## Stellaris® LM3S9B92 RevB1 Errata

This document contains known errata at the time of publication for the Stellaris® LM3S9B92 microcontroller. The table below summarizes the errata and lists the affected revisions. See the data sheet for more details.

**Figure 1. Timing Differences Between Rev B and Rev C Devices**

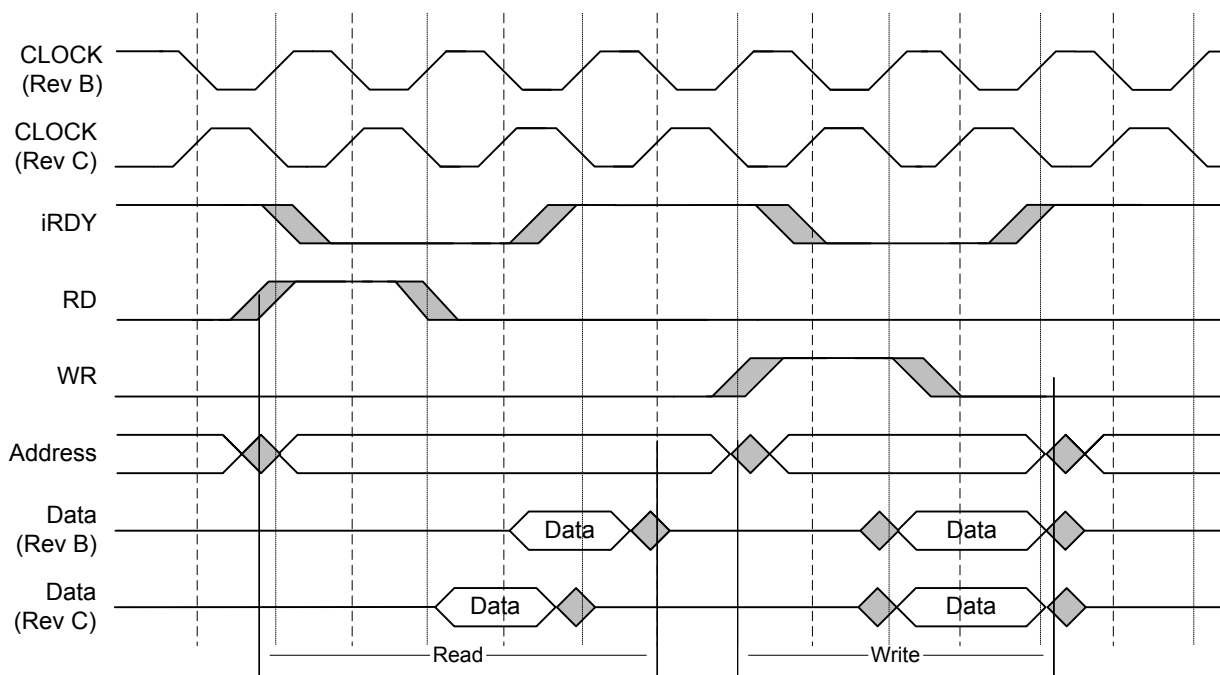
The clock signal that is output on the EPIO31 signal in General-Purpose mode is inverted. Figure 1 on page 13 shows the timing differences between Rev B parts and Rev C parts.

Use the opposite edge for timing when designing with this interface. During read cycles, ensure that the data meets set up and hold times for the appropriate edge as shown in the diagram above.

**Figure 2. Recommended Center-Tap Connections**

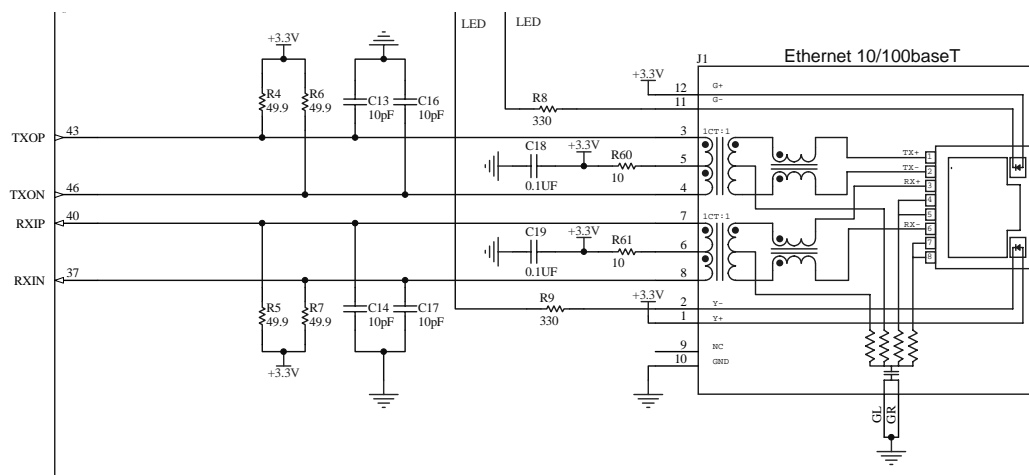
The microcontroller experiences some packet loss with Ethernet cables longer than 50 meters in normal operating conditions.

1. Add 10  $\Omega$  resistor to the center-tap of the transformer as shown in the figure. These resistors should be replaced by a direct connection for silicon that has this item fixed.
2. Continue using the recommended circuit, but limit cable lengths to 50 meters.

**Figure 7. Configuration of External Regulator**

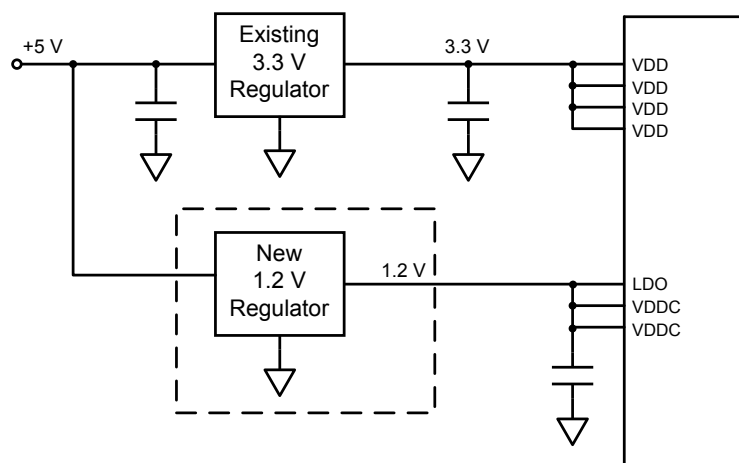
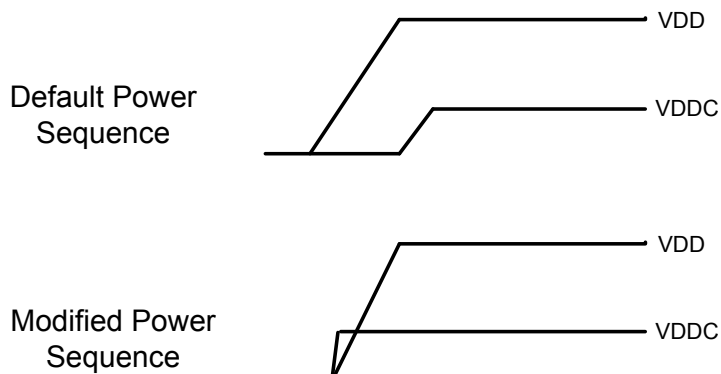
Incorrect power sequencing during power up can disrupt operation and potentially cause device failure.

$V_{DDC}$  must be applied approximately 50  $\mu$ s before  $V_{DD}$ . Normally  $V_{DDC}$  is controlled by the part's internal LDO voltage regulator. The workaround requires the addition of an external regulator (see Figure 7) to ensure that  $V_{DDC}$  sequencing requirements are met (see Figure 8). A recommended regulator is the TI TPS73101DBVR.

This fix mitigates the on-chip power issue, but does not solve it completely. During development, the Flash memory should also be reprogrammed (using LMFlash or another programming tool) at least once a week.
